**Facility Name:** Camas Municipal Pool

**Type:** General use swimming pool/wading pool

### Reopening Swim Season 2018

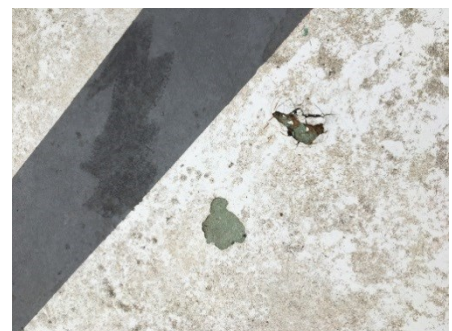
1. The existing fence mesh surrounding the main pool is in poor condition and is in need of replacement. The mesh is rusted and has become detached causing holes in the fencing and sharp points sticking out. When replacing the mesh, fence mesh must be less than ¼ inch to meet WAC 246-260-031(4).
